March 17, 2021

Robert Van Brocklin, Chair, Oregon Transportation Commission
Members of the Oregon Transportation Commission
Salem, Oregon
Via email.

HDR: Memo, April 7, 2016. From Andy Johnson (HDR) and Ron Hughes (AECOM), to Mike Mason and John Makler (ODOT), Subject: Broadway/Weidler Lid Structure Design Concept Feasibility Analysis.

EA Width Illustration: Figure 4: I-5 Cross Section (N/NE Weidler Overcrossing – Existing Conditions and Proposed Improvements), Environmental Assessment, February 15, 2019

CAD

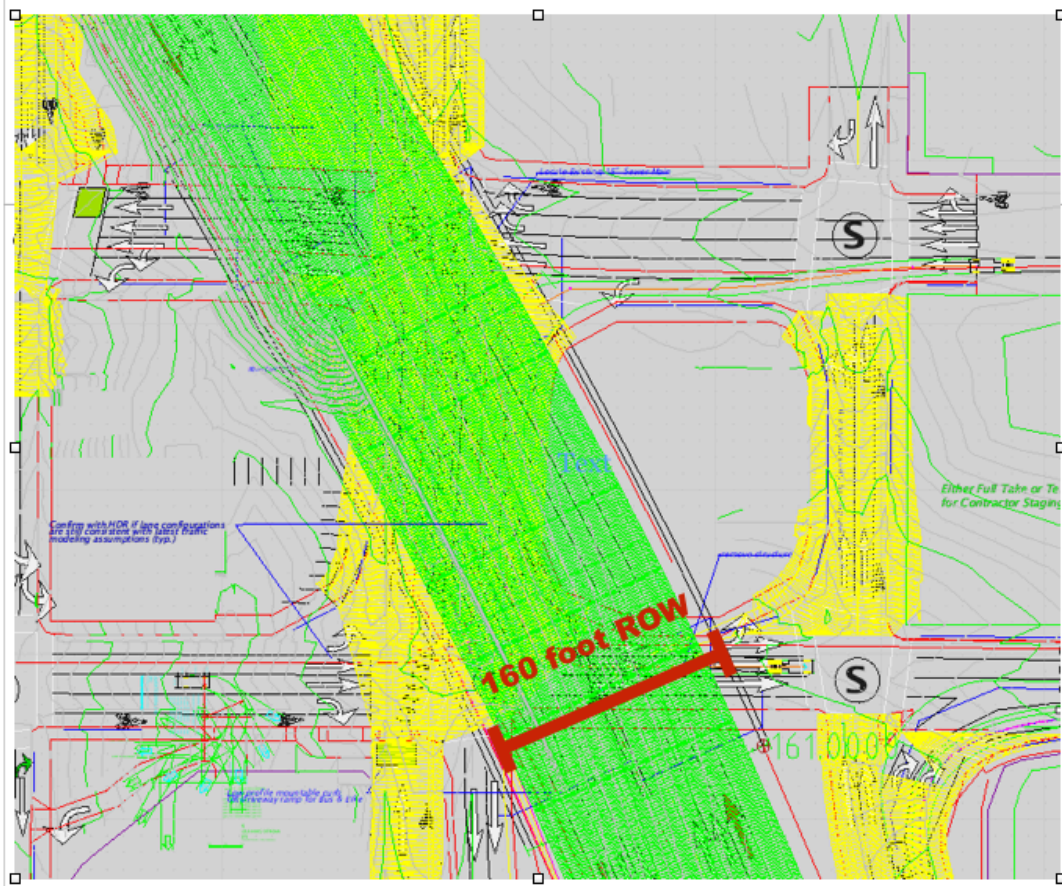
It is now apparent that ODOT, as well as its consultants, have long known and decided that the I-5 Rose Quarter Project would be approximately 160 feet wide as it crosses under Broadway and Weidler Streets in Portland. That is established in a series of documents which are attached to this letter: a 2016 memorandum on the design parameters for freeway caps prepared by consultant HDR [HDR], by electronic CAD files showing the parameters of the proposed construction [CAD], and by a landscape planning cross-section prepared by consultant Marianne Zarkin [Zarkin].

CAD: Images from a computer-aided design files created by ODOT showing the cross-section of the proposed Rose Quarter Freeway at Broadway/Weidler, with the roadway width measured using the CAD files internal dimensions.

ZARKIN

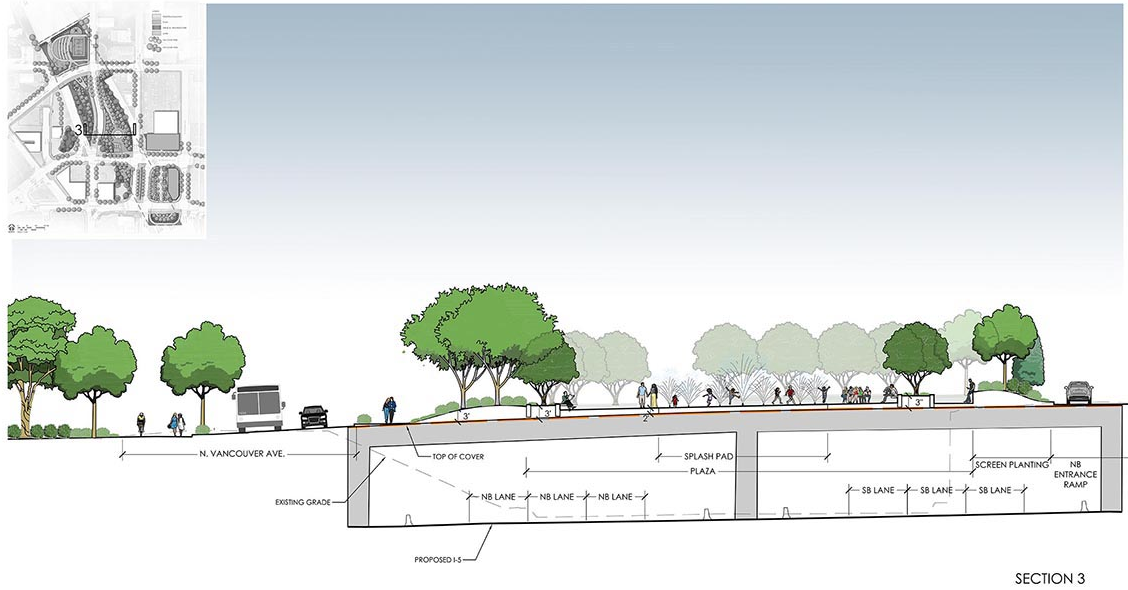
Zarkin: A cross section of the Rose Quarter Freeway prepared by ODOT consultant Marianne Zarkin, undated.

Figure 4. I-5 Cross Section (N/NE Weidler Overcrossing) – Existing Conditions and Proposed Improvements

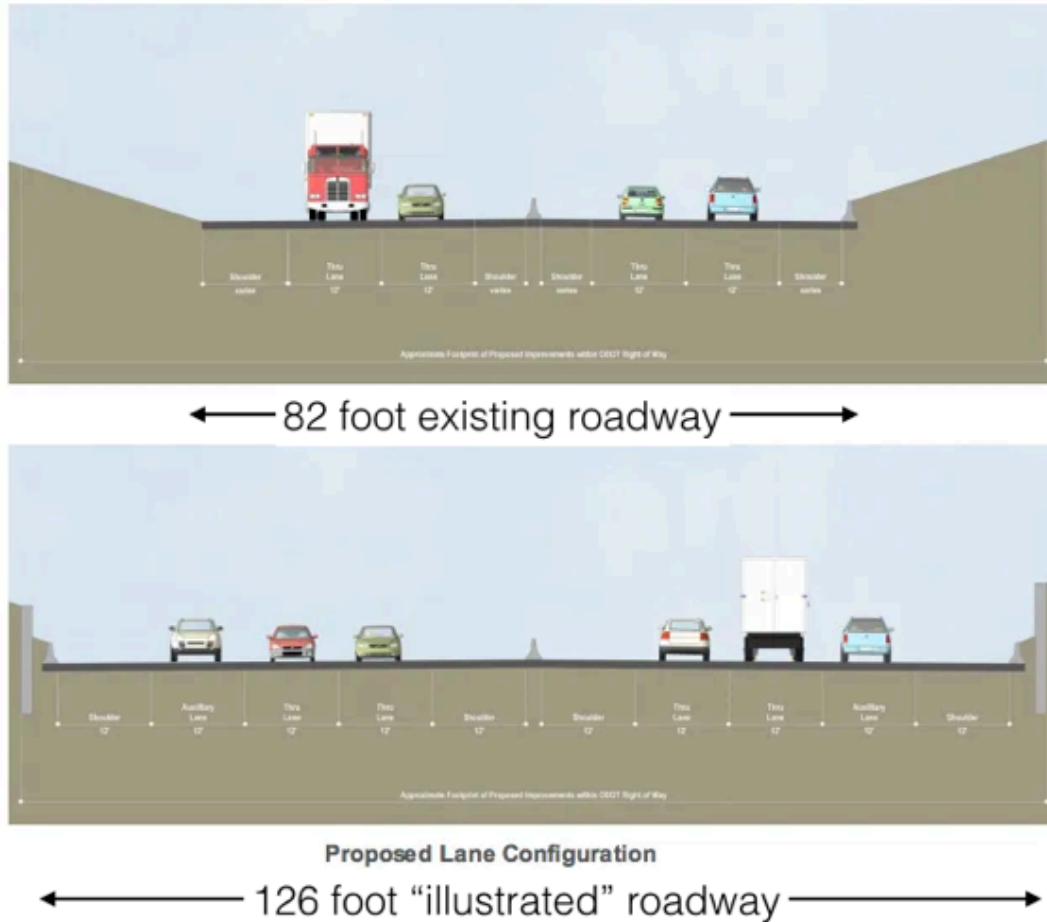
The existence of these detailed plans, each replete with dimensions, shows that the illustration included in the February 15, 2019 Environmental Assessment was intentionally misleading, showing just 126 feet of a proposed roadway width, and omitting an additional 34 feet of roadway (for a total width of 160 feet). Rather than including actual plans, with actual measurements, ODOT chose to create a separate carefully edited and incomplete illustration. This reveals their intent to hide the actual width of the project. (See the EA width illustration and corrected EA width illustration, attached).

Note: 82 foot and 126 arrows not in original document

Corrected EA Width Illustration

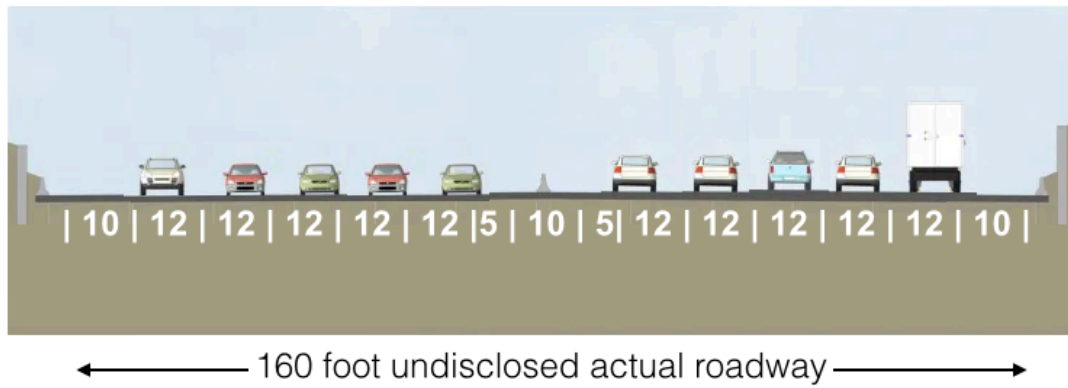
Corrected EA Width Illustration: The previously listed EA width illustration corrected to show the entire 160-foot roadway as specified in CAD, HDR and Zarkin plans.

Note: ODOT illustration corrected to show that a ten-lane freeway fits in the 160 roadway.
